CITY OF DALLAS  
CITY PLAN COMMISSION  
Thursday, April 9, 2020  
AGENDA

- (1) **S190-111**  
(CC District 7)
- An application to create three lots with area of 6,128 square feet each from a 0.422-acre (18,383 square feet) tract of land in City Block J/1486 on property located on Penelope Street, southwest of Gertrude Street.
- Applicant/Owner: Jamie Huerta  
Surveyor: Brian S. Rhodes  
Application Filed: March 12, 2020  
Zoning: PD 595 (R-5(A))  
Staff Recommendation: **Approval**, subject to compliance with the conditions listed in the docket.

**CITY PLAN COMMISSION****THURSDAY, APRIL 9, 2020****FILE NUMBER:** S190-111**SENIOR PLANNER:** Mohammad H. Bordbar**LOCATION:** Penelope Street, southwest of Gertrude Street**DATE FILED:** March 12, 2020**ZONING:** PD 595 (R-5(A))**PD LINK:** <http://dallascityattorney.com/51P/Supp%2058/ARTICLES/ARTICLE%20595.pdf>**CITY COUNCIL DISTRICT:** 7 **SIZE OF REQUEST:** 0.422-acre**MAPSCO:** 46R**APPLICANT/OWNER:** Jamie Huerta

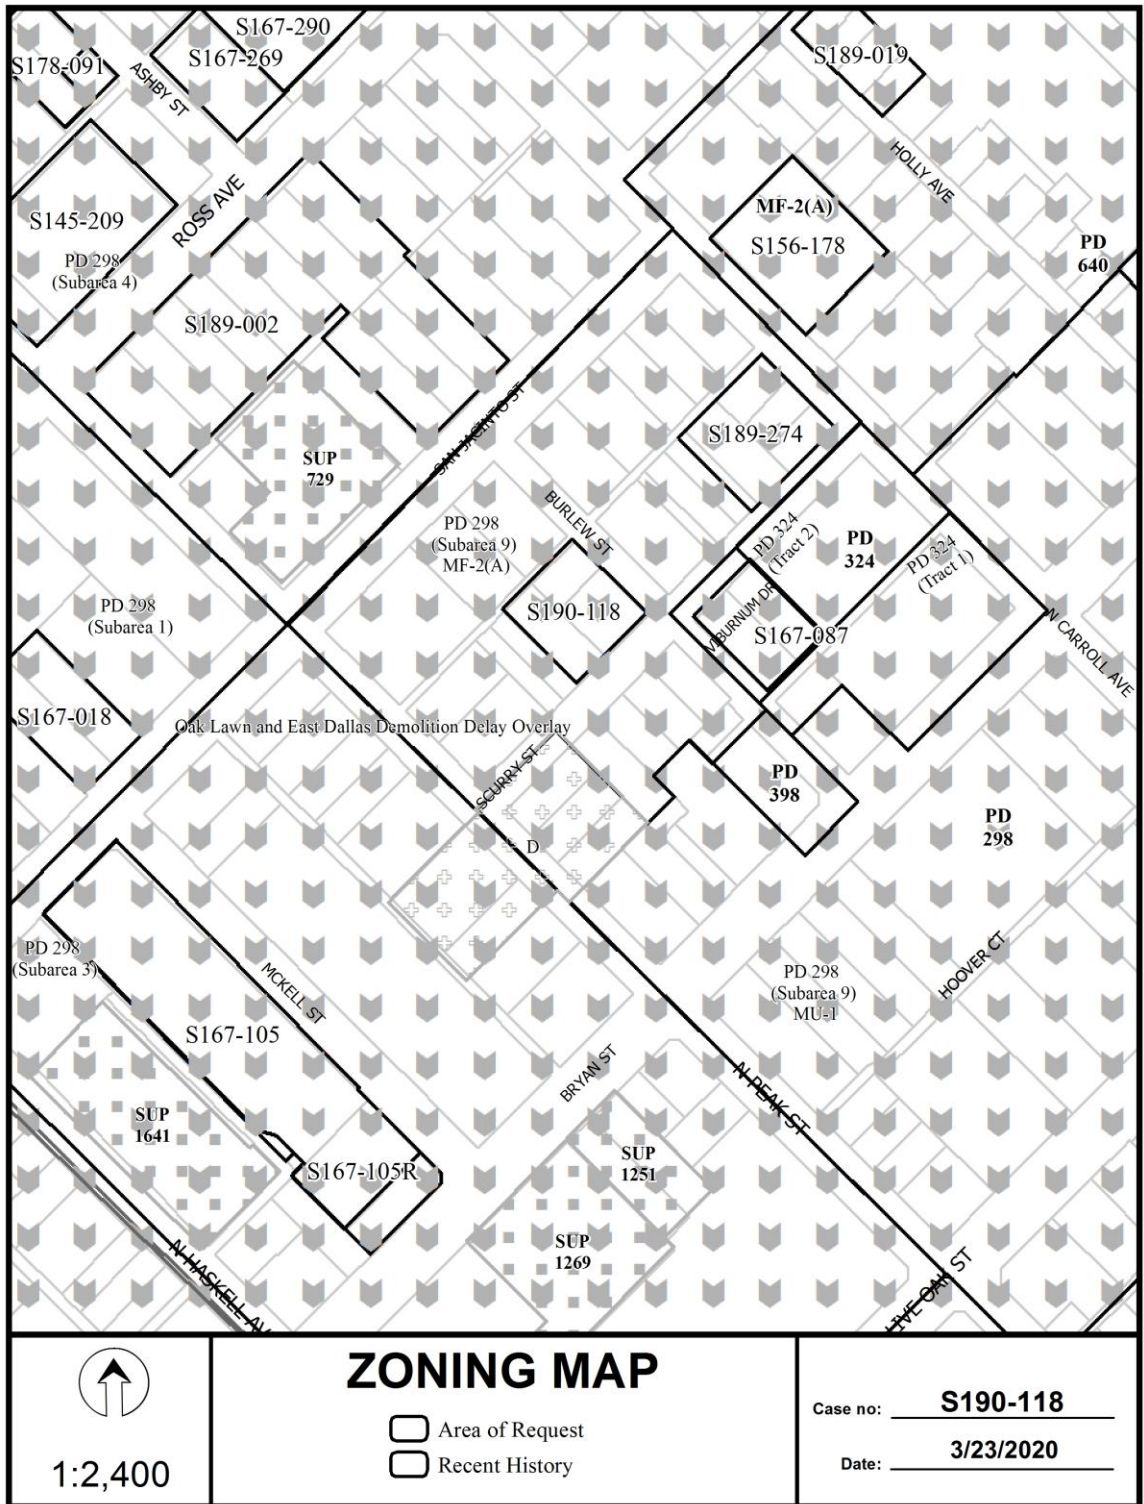
20. On the final plat, dedicate a 15-foot by 15-foot Alley Sight Easement at the intersection of Burlew Street & the alley. Section 51A-8.602(e),
21. Comply with Mill Creek drainage requirement. Finish floor elevation must be 3 feet above nearest inlet, top of curb. Section 51A-8.611(d), C.9 of Mill Creek, Master Drainage Plan Study.
